SUNDRY NOTICES AND REPORTS ON WELLS

Mewbourne Oil Company requests that the following changes be made to the Sandlot 9/8 Fee #523H Well (API #30-015-54643):

SANDLOT 9/8 FEE #523H

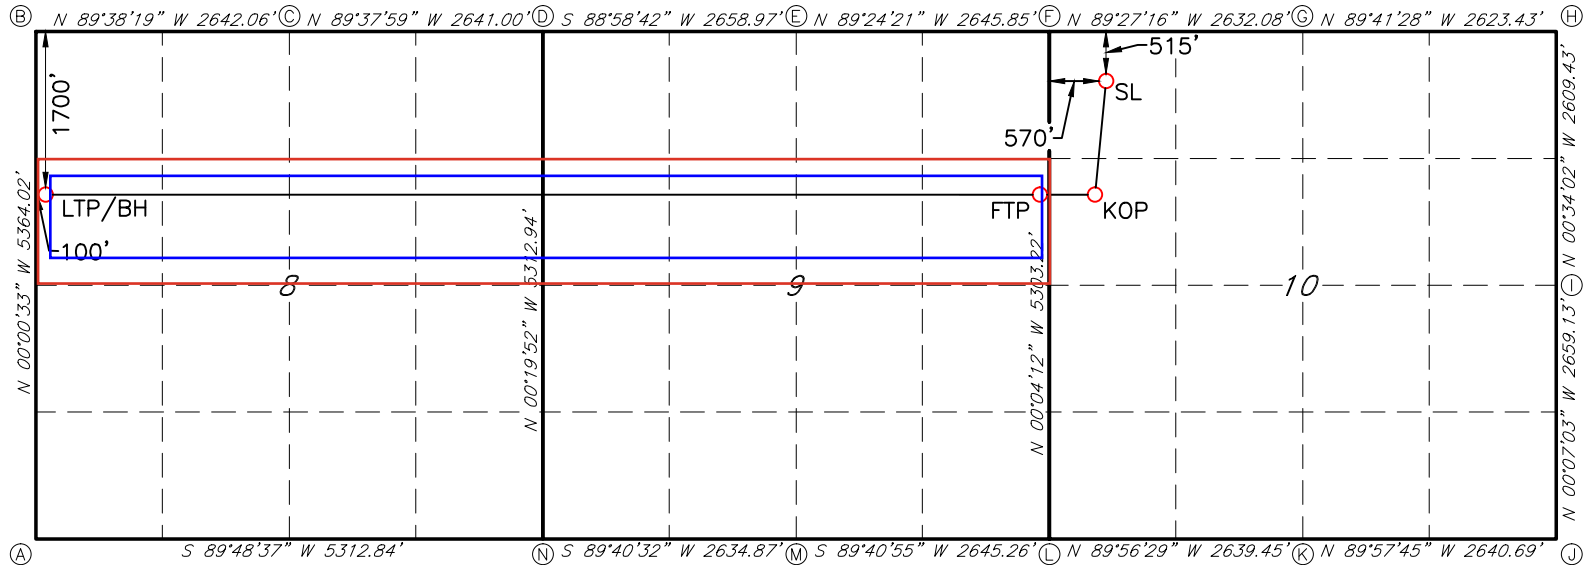
1. Change SHL f/ 295 FNL & 760 FWL (10) to 515 FNL & 570 FWL (10)
2. Change BHL f/ 1980 FNL & 100 FWL (8) to 1700 FNL & 100 FWL (8)
3. Attached New C102 reflecting these changes.

SURFACE LOCATION (SL)
515' FNL & 570' FWL (SEC.10)
N: 514124.2 - E: 587402.8

KICK OF POINT (KOP)
1700' FNL & 473' FWL (SEC.10)
N: 512940.5 - E: 587308.3

FIRST TAKE POINT (FTP)
1700' FNL & 100' FWL (SEC.9)
N: 512946.0 - E: 586735.5

BOTTOM HOLE (BH)
1700' FNL & 100' FWL (SEC.8)
N: 512957.9 - E: 576348.9
